YANKEE ATOMIC ELECTRIC COMPANY

Subject: Response to the NRC Questions on RELAP5YA

RESPONSE TO 80 QUESTIONS
ON RELAP5YA

July 1, 1985

Figure IX.18-1: Marviken Test 10 Dome Pressure
RELAP5YA Standard Critical Flow Model Predictions

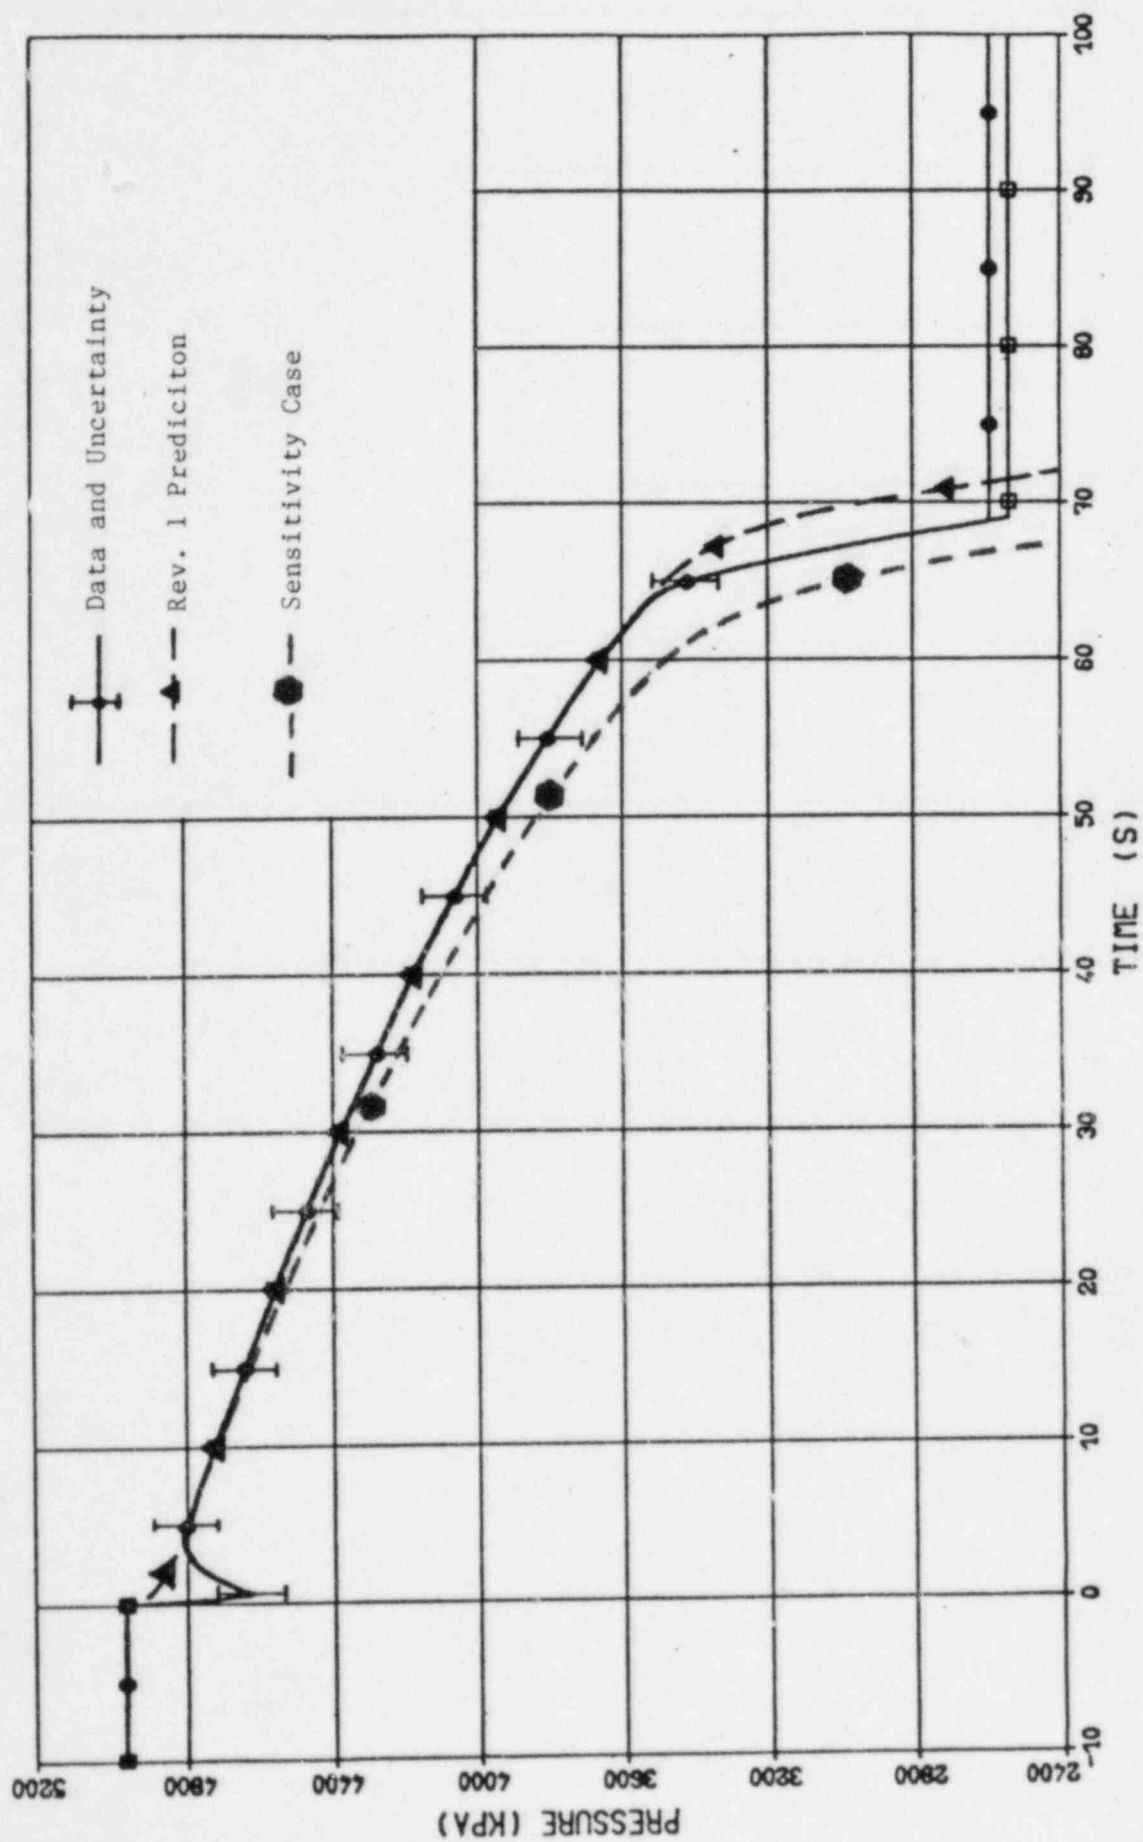
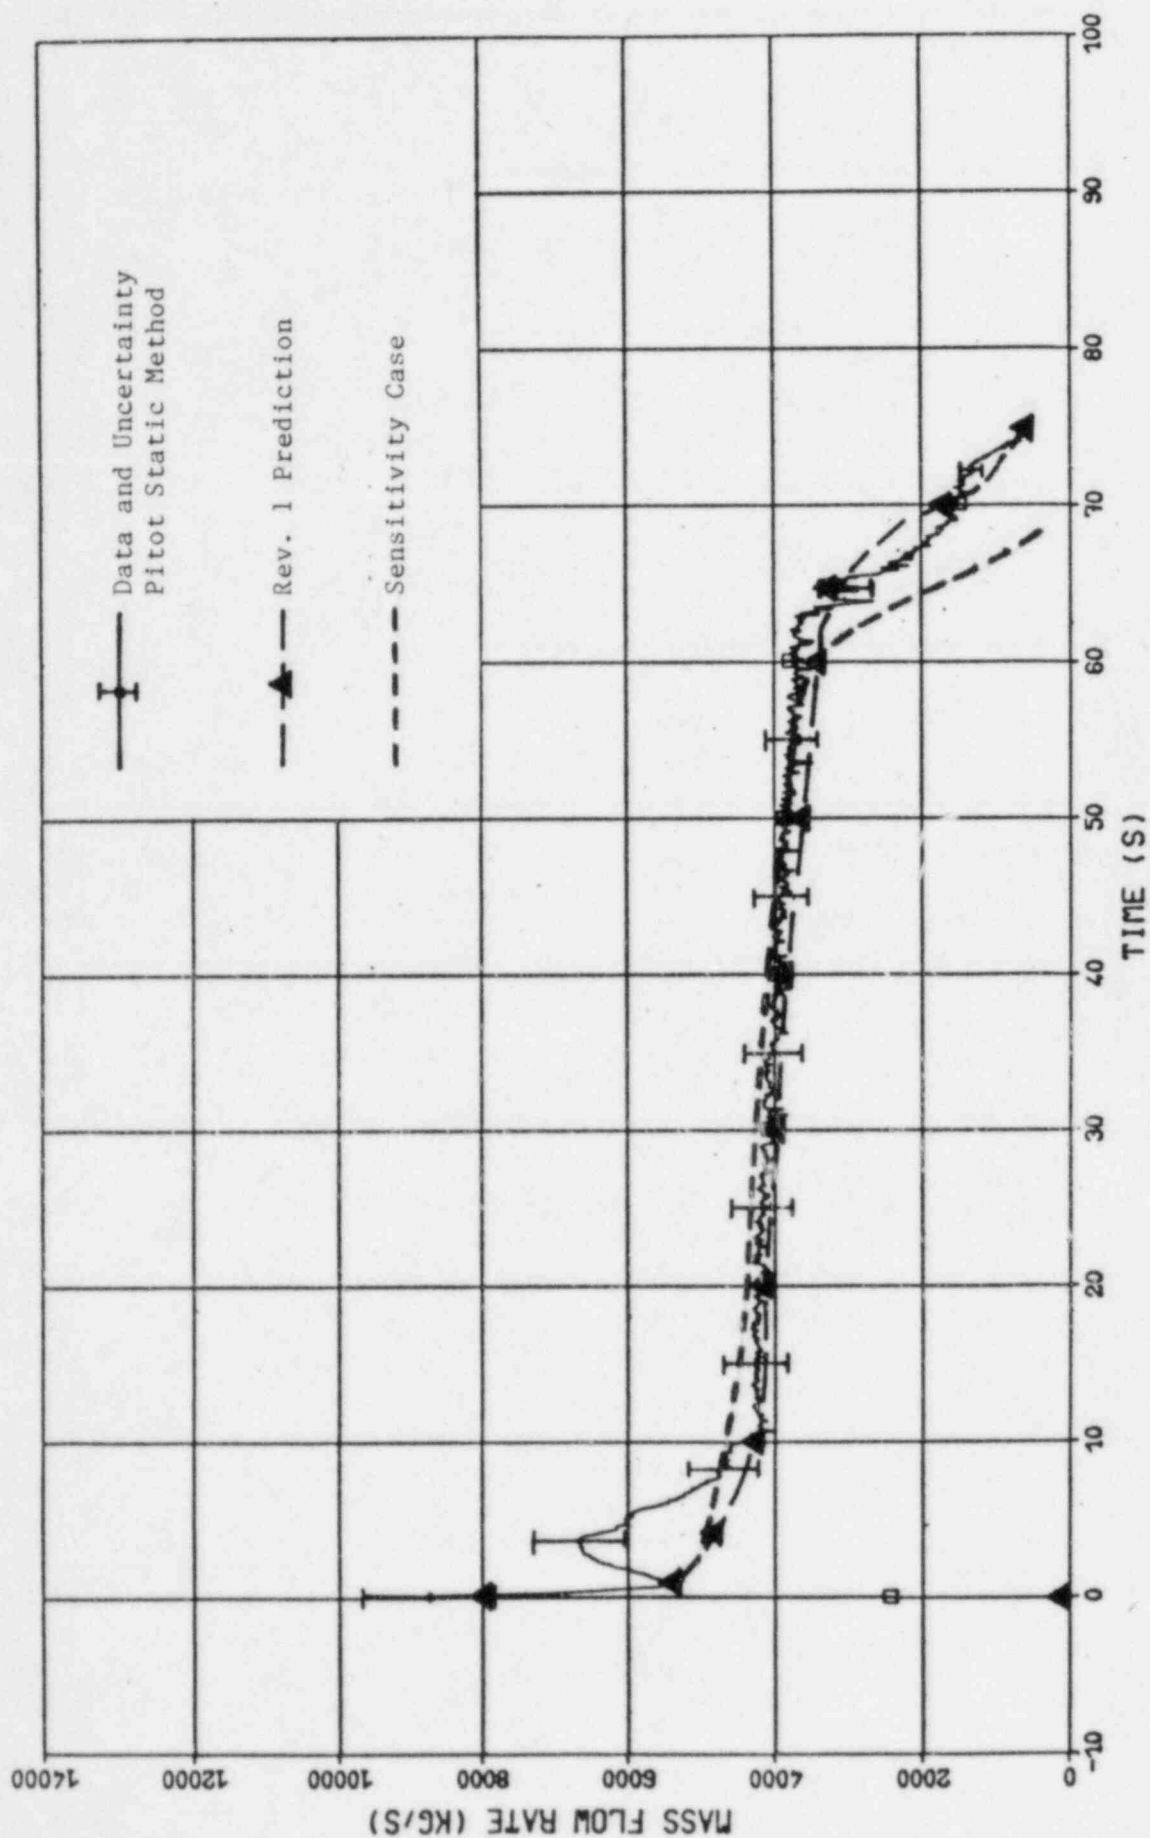
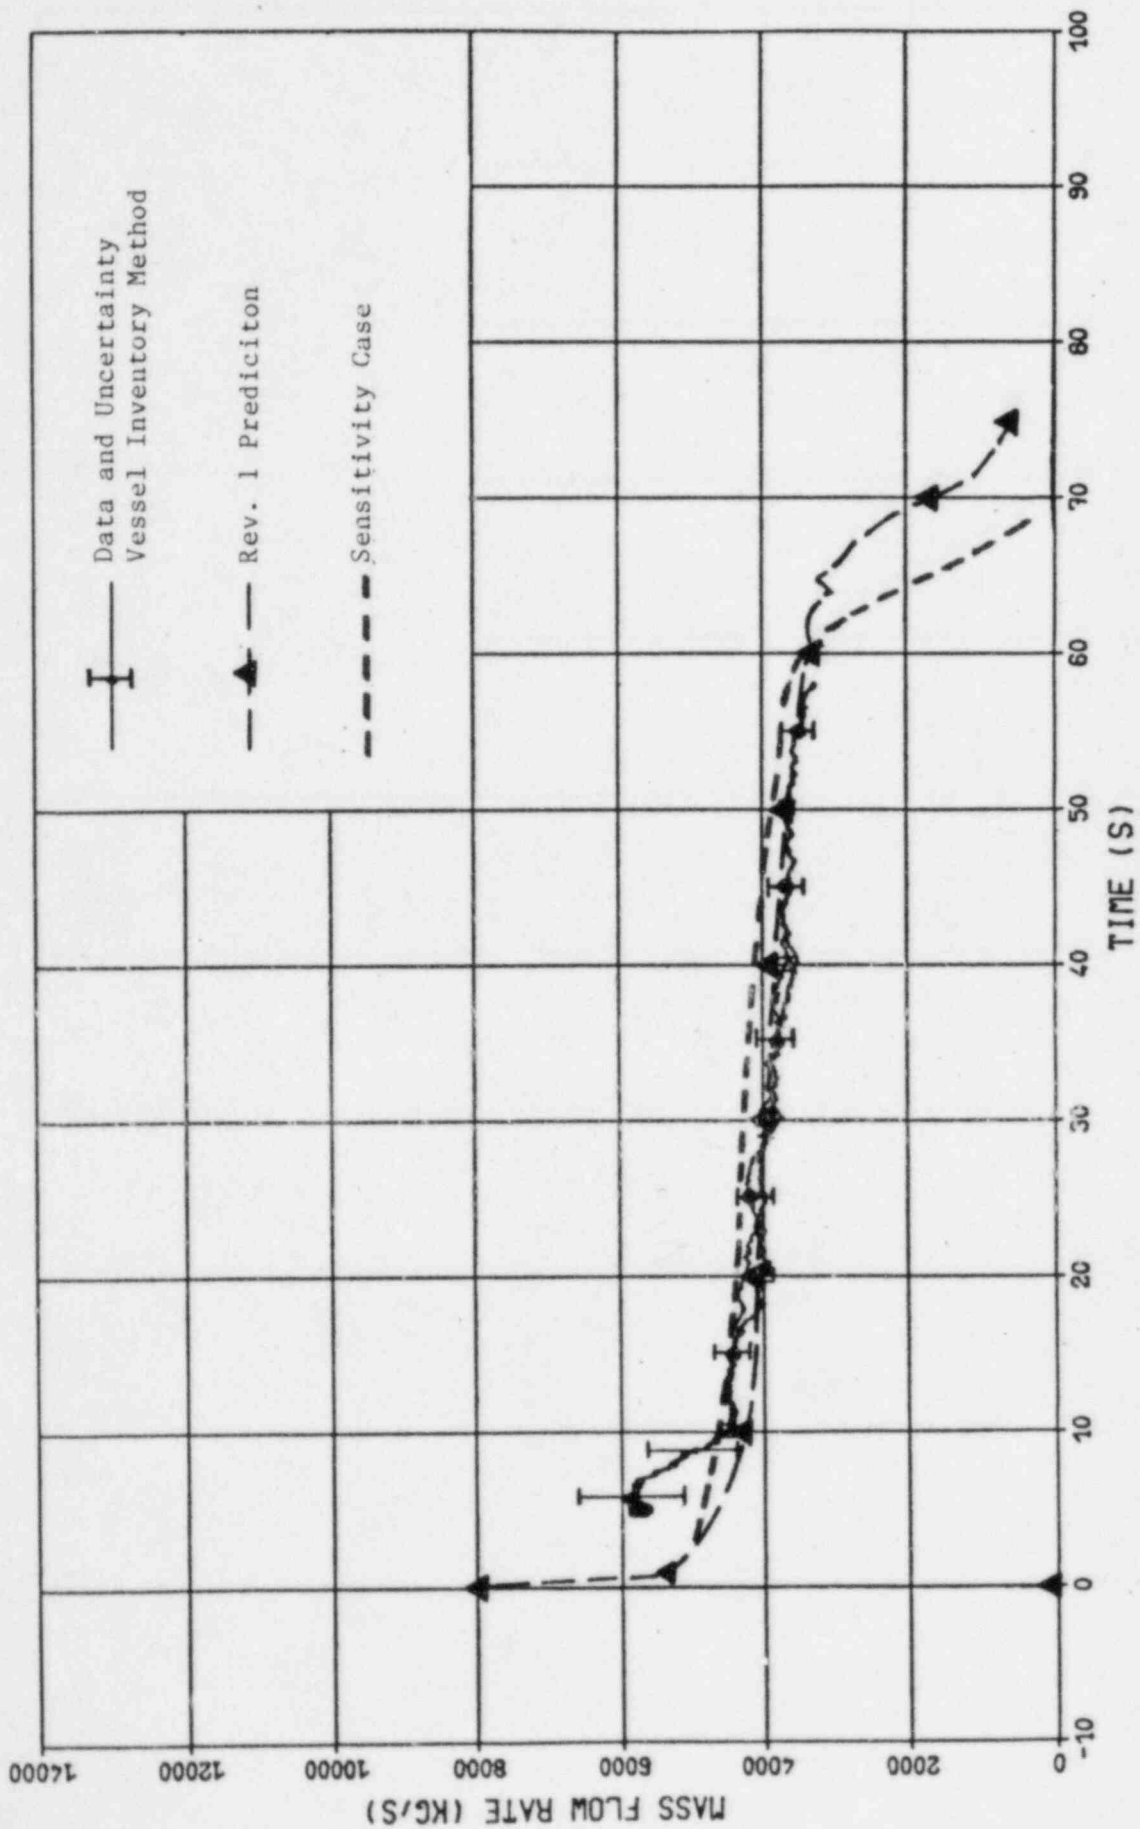
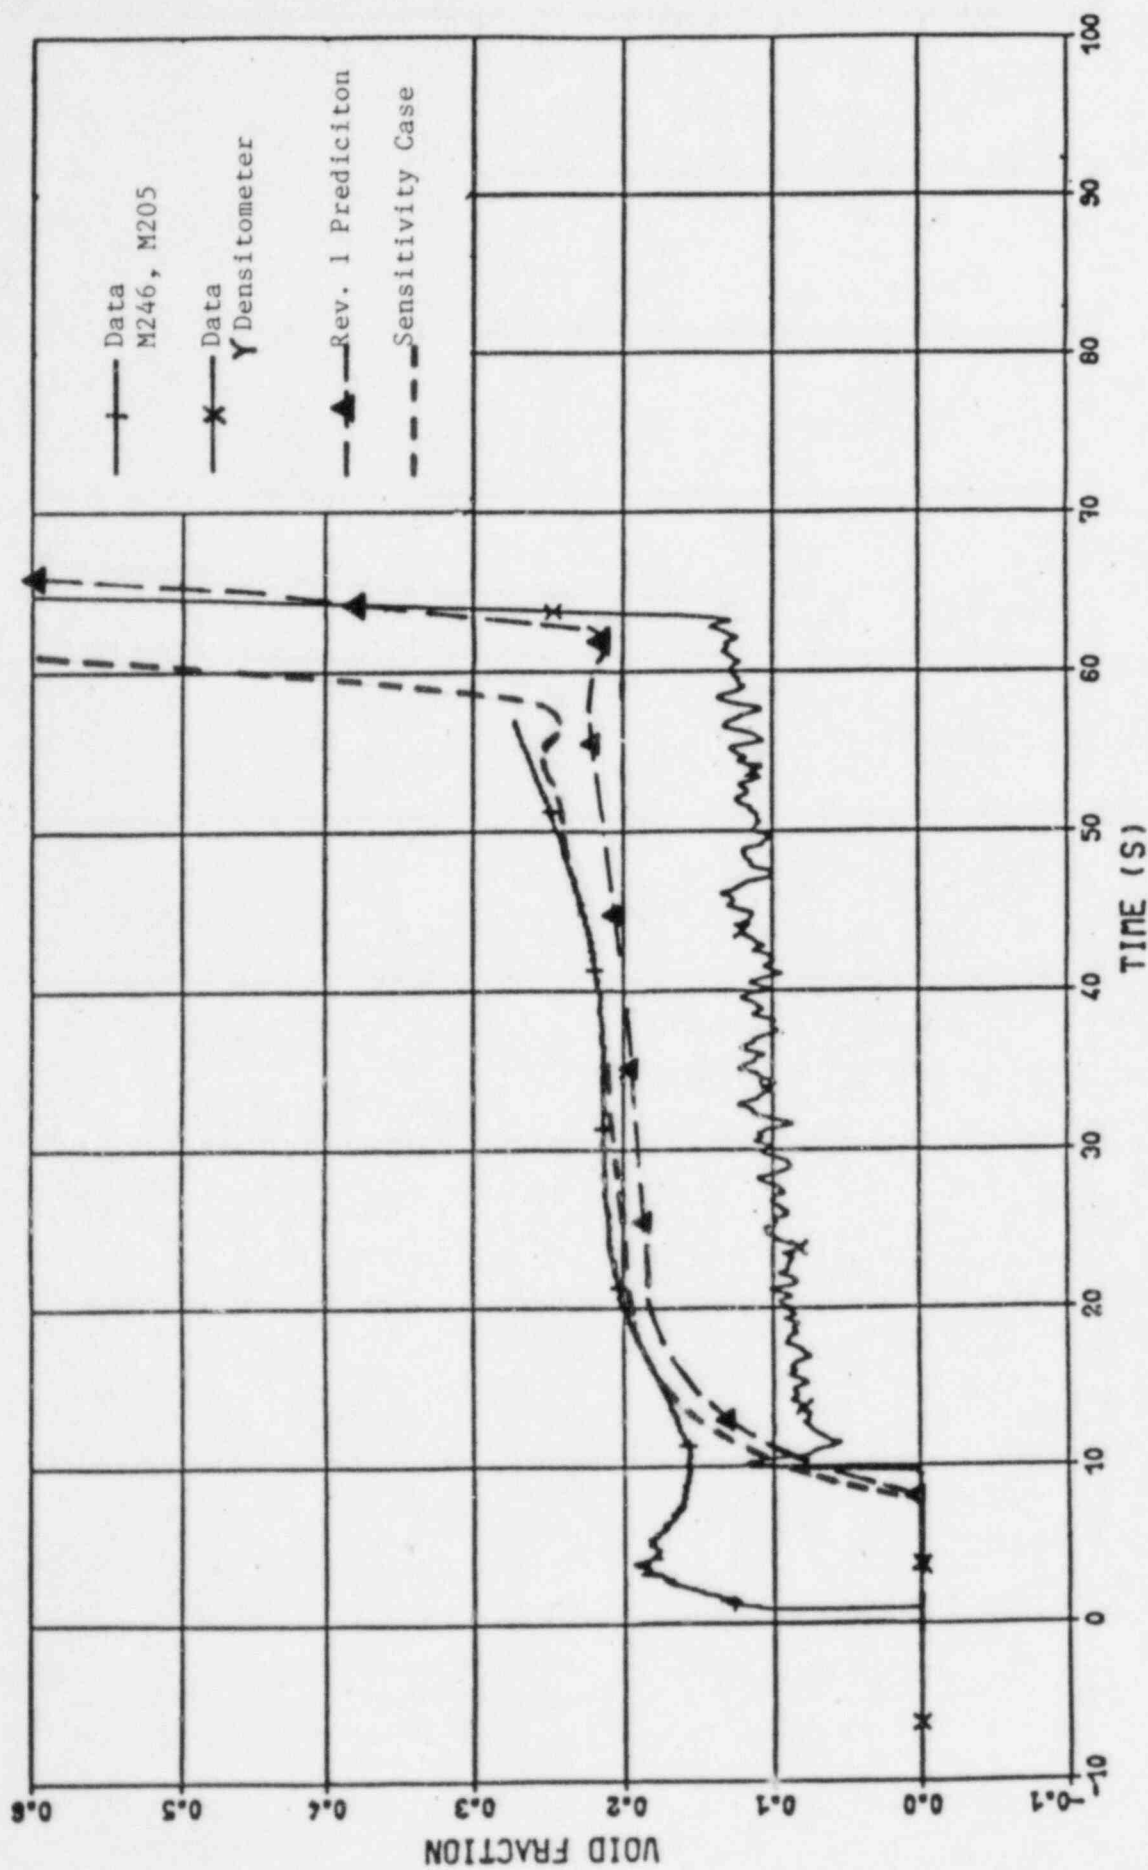
Figure 15 in Appendix A of Reference IX.18-1 shows that the virtual mass coefficient in Equation (149) has a significant effect upon the two-phase equilibrium sonic speed. Thus, this coefficient will have a significant effect upon the mass mean Mach number defined by Equations (148), (149) and (154). Figure 16 (Reference IX.18-1) shows the coefficient, D, defined in Equation (150) that multiplies the relative Mach number is bounded by ± 0.6 . The relative Mach number for critical flow conditions is generally an order of magnitude less than

This observation was checked by rerunning the Marviken Test 10 Best-Estimate Calculation and assuming $C=\infty$ in Equation (150) consistent with the assumed value in Equation (149). The results are shown in Figures IX.18-1 through IX.18-5 as the sensitivity case indicated by the small dash lines. These results show the break flow rate and discharge pipe void fraction are slightly higher. This causes the vessel dome pressure to decrease faster and moves to outside the uncertainty bars on the measured dome pressure. Both the Revision 1 prediction and the sensitivity case predict the escaped mass history within the uncertainty of the reported test data. Therefore, we believe the original model given by Equation (245) remains the best model to use for critical flow calculations at this time.
